November 1, 2016
ET 16-0030

Subject: Docket No. 50-482: Relief Request Number I4R-03, Request for Relief from Paragraph-3200(b) of ASME Code Case N-729-1 for Reactor Vessel Head Penetration Nozzle Welds and Relief Request I4R-04, Request for Relief from the Requirements of ASME Code Case N-729-1

**Wolf Creek Nuclear Operating Corporation
10 CFR 50.55a Request I4R-03**

Wolf Creek Nuclear Operating Corporation
10 CFR 50.55a Request I4R-04
Relief Requested from the Requirements
of ASME Code Case N-729-1

Figure 1

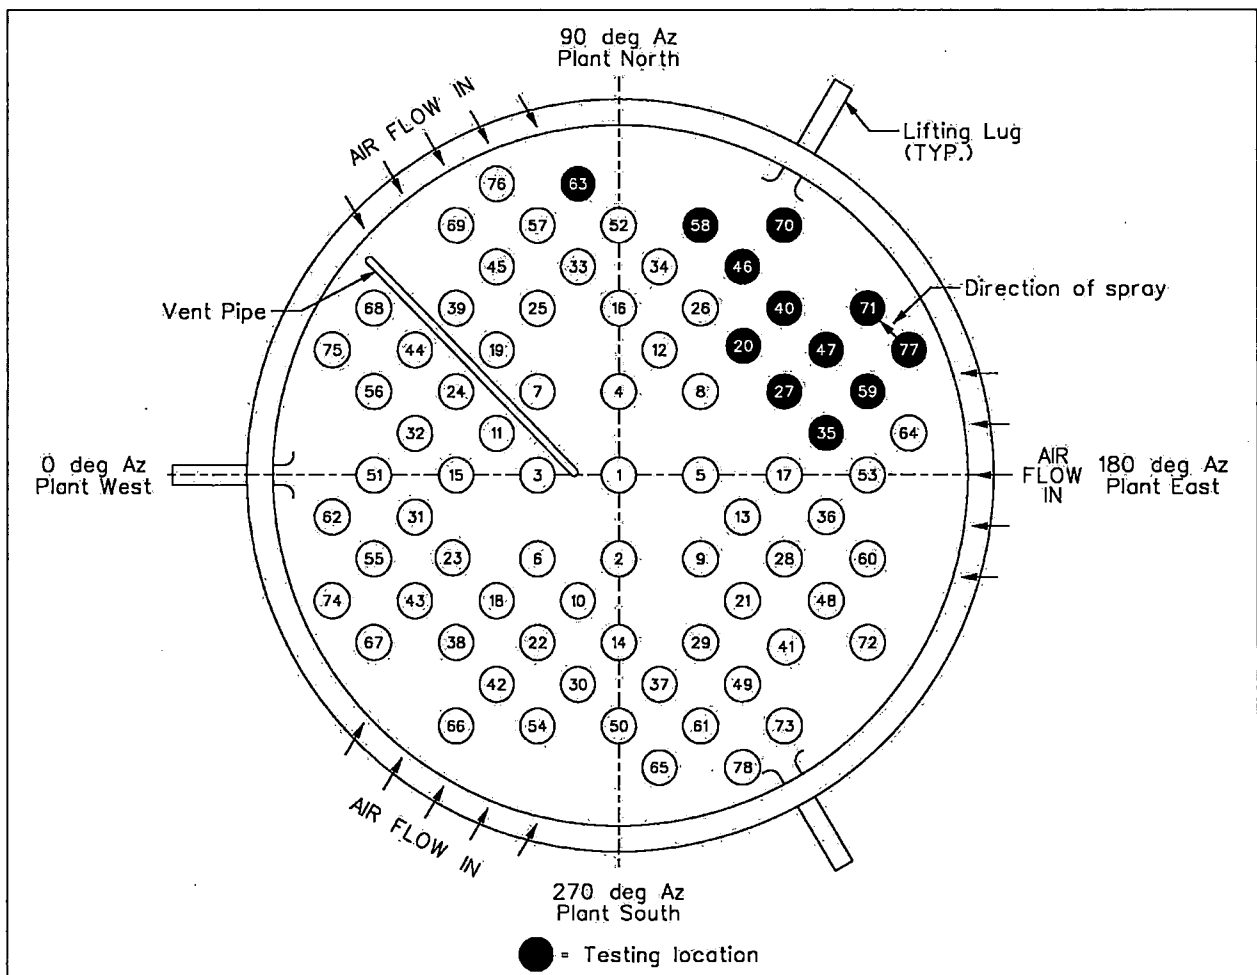
Based on VT-2, deposits resulting from leakage in the canopy seal weld area above the closure head surface on penetration 77 were found on the RVCH. These deposits were found in locations consistent with leakage from the canopy seal weld traveling down onto the RVCH and penetration nozzles. WCNOG will perform supplemental volumetric examinations of the obscured penetrations.

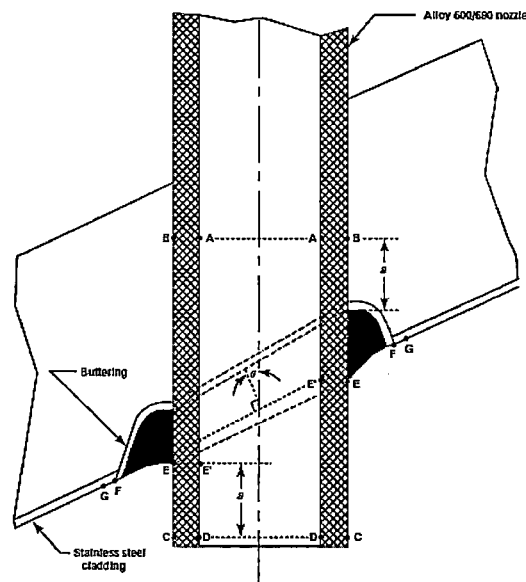
The volumetric examination is the area from points A-B-C-D. The leak path assessment will cover the interface between the nozzle and the carbon steel head to at least 2" above the J-groove weld. Performing the leak path assessment in lieu of the surface examination of the J-groove weld will demonstrate that the boric acid deposits observed on the exterior of the head were a result of the canopy seal weld leak.

For both sets of Penetration Nozzles, the 12 obscured by boron deposits and the remaining 66, WCNOG proposes to perform a demonstrated volumetric leak path assessment (in addition to the volumetric examination) in lieu of the surface examination of the partial penetration weld. The leak path assessment can be performed in tandem with the nozzle tube volumetric exams and will not add any additional dose and will not increase the length of the outage. This combination (volumetric examination of the nozzle tube and volumetric leak path assessment) will provide confirmation that all of the deposits observed on the RV closure head were a result of the canopy seal weld leak. WCNOG believes the combination of volumetric exams and leak path assessment will provide an acceptable level of assurance in the condition of each penetration. This is because, as shown in the figure below, the two examinations will verify there are no indications in the nozzle tube and verify there has been no leakage in the penetration tube to RVCH interface.

Figure 1

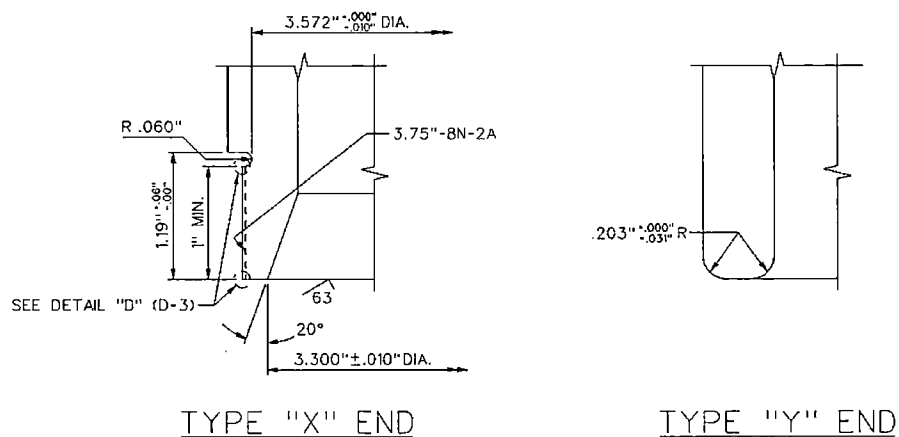
RVCH CRDM penetrations at WCGS have two styles of ends, referred to as Type "X" and Type "Y" (Figure 1). Penetrations 1 through 73 are Type "Y" that are essentially a smooth wall cylinder with a radius at the outer diameter and inner diameter. Penetrations 74 through 78 have a threaded outside diameter and an internal taper.

The design of RVCH penetration nozzles 74 through 78, referred to as Type "X", (Figure 1) includes a threaded section, approximately 1.19 inch in length at the bottom of the nozzles. These penetrations are located at the 48.7 degree location. The dimensional configuration at this location is such that the distance from the lowest point at the toe of the J-groove weld to the top of the threaded region could be less than the required coverage dimension "a" shown in Figure 2 of ASME Code Case N-729-1. Therefore, deviation from the required inspection coverage is sought for RVCH penetrations 77 and 78, as the required coverage for these two penetrations cannot be obtained.

Figure 2

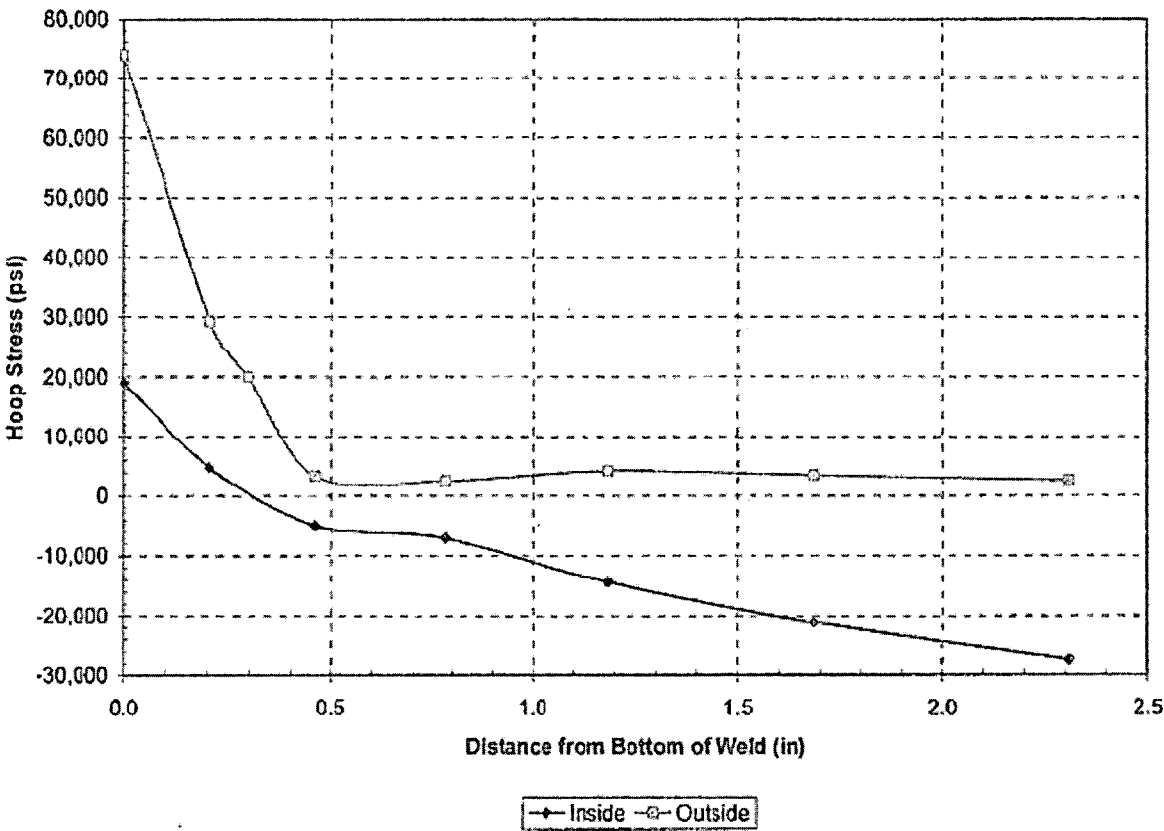
The hoop stress distribution plots for penetrations 77 and 78 are provided in Figure 2 of this submittal. The hoop stress distribution plots in Figure 2 indicate that the minimum achievable inspection coverage below the bottom of the J-groove weld insures stresses remain below 20 ksi tensile over the entire region outside the alternative examination zone but within the examination zone defined in Figure 2 of ASME Code Case N-729-1. The hoop stress distribution plots display the downhill side as this is more limiting. Also, stress distribution plots shown are for the inside and outside surface. Table 3 summarizes the distance from below the toe of the downhill side J-groove weld to where both the inside and outside surface hoop stress drops below 20 ksi for penetrations 77 and 78.

Penetration Nozzle No.	Source	Distance Below Toe of Downhill Side J-Groove Weld Where Hoop Stress < 20 ksi (inch)
77 and 78	Figure 2	0.30

Figure 3

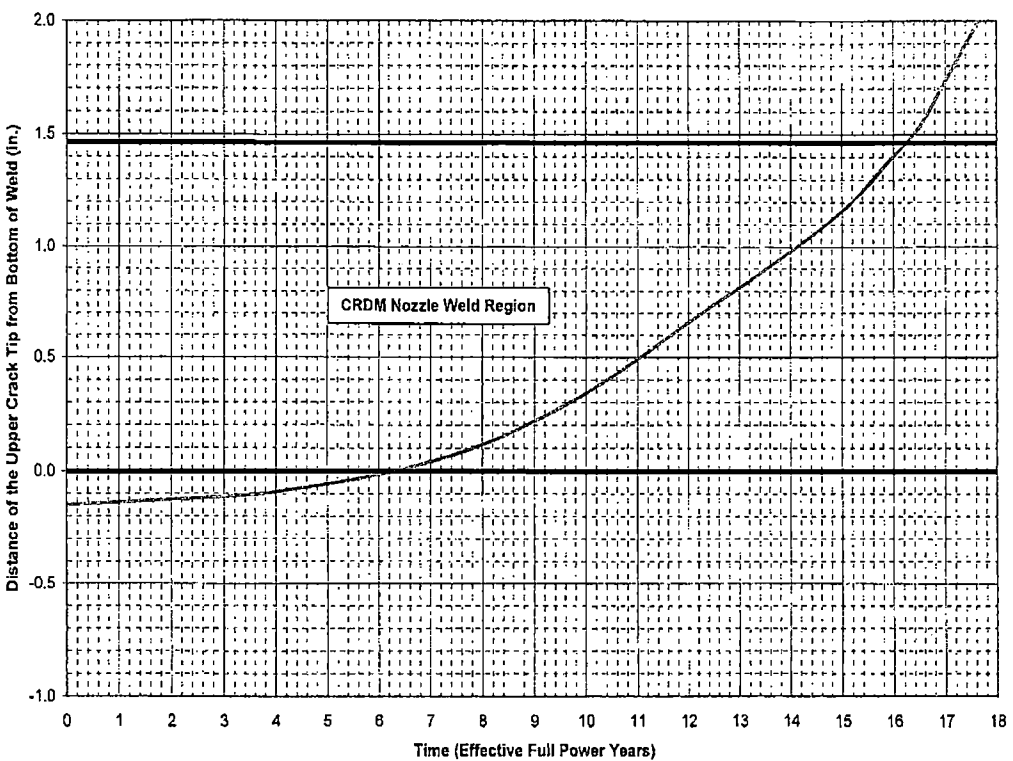
The fracture mechanics analysis was performed using input from the previously discussed stress analysis. The results of the analysis are shown as flaw tolerance charts, which can be used to determine minimum required inspection coverage. This ensures that any flaws initiated below the weld, in the region of the penetration nozzle not being inspected, would not reach the bottom of the weld before the next inspection. The flaw tolerance chart for penetrations 77 and 78 is presented in Figure 3.

The flaw tolerance chart in Figure 3 demonstrates that a postulated through-wall flaw at the bottom edge of the proposed alternative examination zone will not grow to the toe of the J-groove weld within an inspection interval of four refueling cycles. The crack growth prediction shows greater than six effective full power years (EFPY) of operation required to grow the postulated flaw to the toe of the weld. Additionally, the assumed initial upper extremity locations of axial through-wall flaws are conservative based on achievable inspection coverage, because the assumed upper crack extremities are located within the achievable inspection zone.

Figure 4
Relationship of the J-groove Weld to the Threaded Area

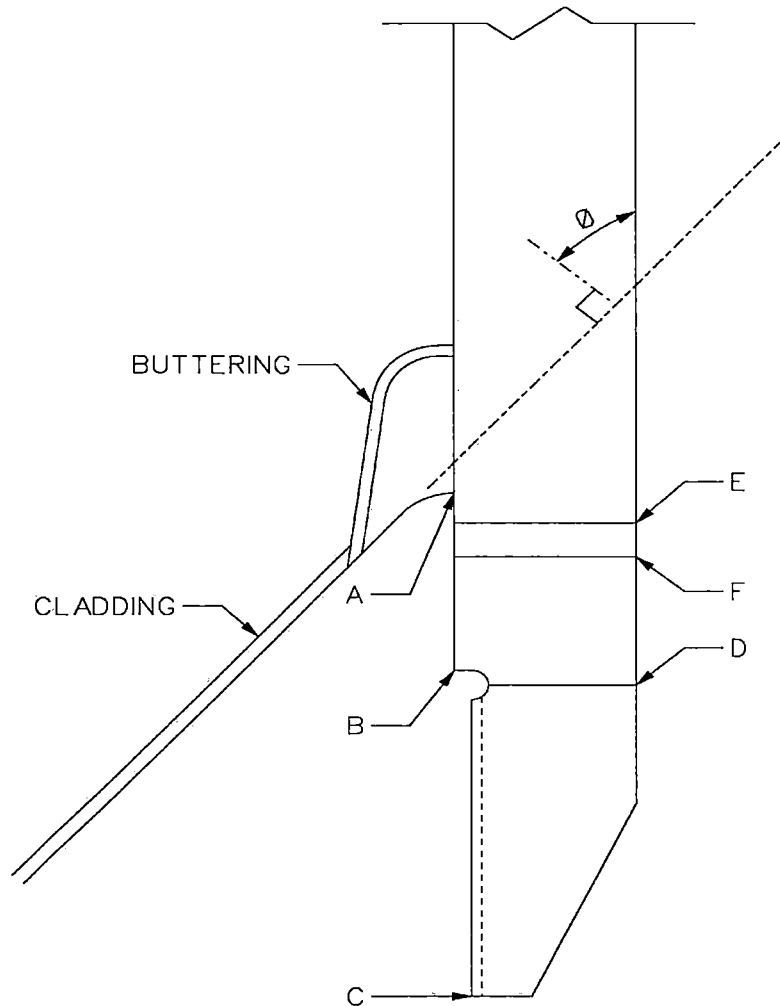
$A - E = 0.15''$ (A postulated through wall flaw tip at this point will not reach the bottom of the weld until 6 EFPYs)

$F = 0.3''$ below the toe of the J-groove weld. The nozzle tube below this point has less than 20 ksi tension.

$$A - D = 0.6'' = \text{the measurement using both the Axial and Circumferential scan data}$$

$$A - D = 0.88'' = \text{the measurement using the Circumferential scan data}$$

$$A - D = 0.64'' = \text{the measurement using the Axial scan data}$$

As an alternative to the volumetric and surface examination coverage requirements shown as dimension "a" in Figure 2 of ASME Code Case N-729-1, WCGS proposes to examine at least 0.5" below the toe of the lowest point of the J-groove weld. The required examination coverage dimension for the other penetrations will be met or exceeded. The use of 0.5" will allow for improvements/changes in the vendor equipment that could lead to a more conservative measurement in the distance from the toe of the weld to the threaded area
